UNITED STATES
DEPARTMENT OF THE INTERIOR
BUREAU OF LAND MANAGEMENT

FORM APPROVED
OMB NO. 1004-0137
Expires: January 31, 2018**SUNDRY NOTICES AND REPORTS ON WELLS**
*Do not use this form for proposals to drill or to re-enter an abandoned well. Use form 3160-3 (APD) for such proposals.*5. Lease Serial No.
NMNM56749

1. Type of Well <input checked="" type="checkbox"/> Oil Well <input type="checkbox"/> Gas Well <input type="checkbox"/> Other		8. Well Name and No. EXACO FEDERAL 03	
2. Name of Operator COG OPERATING LLC		9. API Well No. 30-025-31398-00-S1	
3a. Address ONE CONCHO CENTER 600 W ILLINOIS AVENUE MIDLAND, TX 79701-4287		3b. Phone No. (include area code) Ph: 432-580-7161	
4. Location of Well (Footage, Sec., T., R., M., or Survey Description) Sec 14 T19S R33E SESW 660FSL 1980FWL		10. Field and Pool or Exploratory Area E GEM	
		11. County or Parish, State LEA COUNTY, NM

Permanent Abandonment of Federal Wells
Conditions of Approval (LPC Habitat)

Author:	Carter Wade	
Well Name	Texaco Federal	Well No. #3
Field	Delaware	API #: 30-025-31398
County	Lea	
State	New Mexico	
Date	6/18/2019	
GL	3,661'	
KB	3,671'

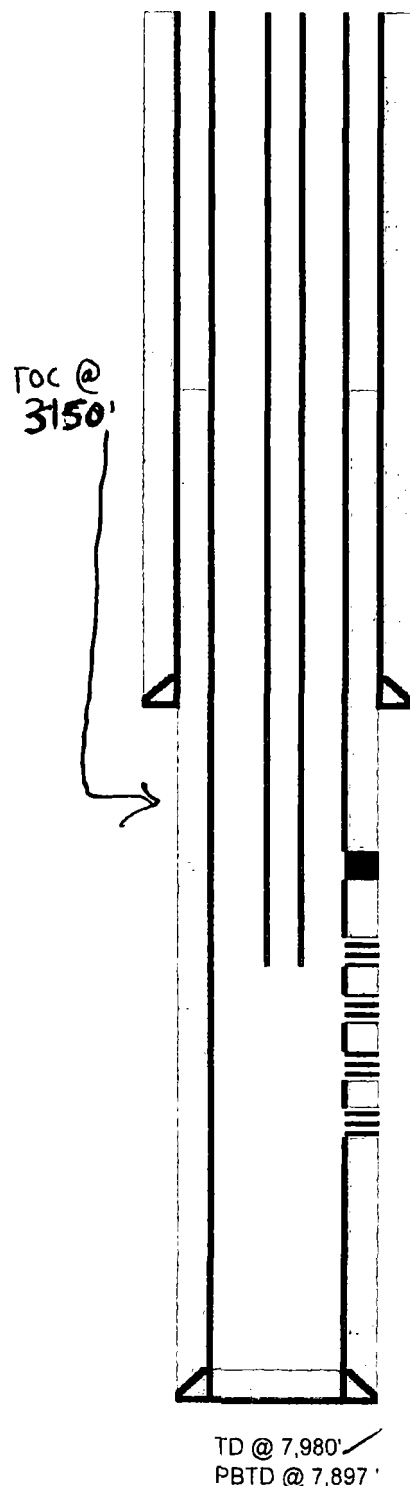
** BLM REVISED ** BLM REVISED ** BLM REVISED ** BLM REVISED ** BLM REVISED

8-5/8" (24#) @ 1,635' w/850 sx
 TOC @ surface ✓

Sqz perms from 5,111' - 5,175' w/ 525 sx (TOC @ 3,160') ✓

5-1/2" (17.20#) @ 7980' w/450 sx ✓
 TOC @ 3,150' ✓

T/Salt - 1632 ✓

B/Salt - 3074 ✓

Del - 5930 ✓

* Add Top Delaware
Spot 25 SX from 5980-5800

Author:	Carter Wade	
Well Name	Texaco Federal	Well No. #3
Field	Delaware	API #: 30-025-31398
County	Lea	
State	New Mexico	
Date	6/18/2019	
GL	3,661'	
KB	3,671'

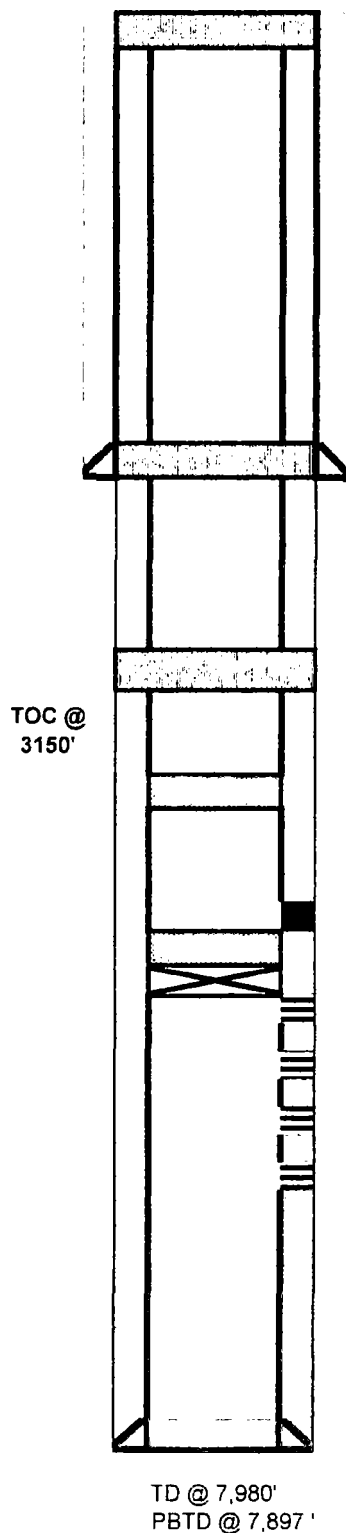
5. Perf & Sqz 30 sx cmt @ 60'-Surface.

4. Perf & Sqz 50 sx cmt @ 1700-1500'. WOC & Tag (T/Salt & 8 5/8" Shoe)

3. Perf & Sqz 50 sx cmt @ 3125-2925'. WOC & Tag (B/Salt)

2. Spot 25 sx cmt @ 4300-4100'. (Queen)

1. Set 5 1/2" CIBP @ 6953'. Circulate hole w/ MLF. Pressure test csg.

Spot 25 sx cmt @ 6953-6753'.

SEE ATTACHED FOR
CONDITIONS OF APPROVALBelow ground level dry hole marker required
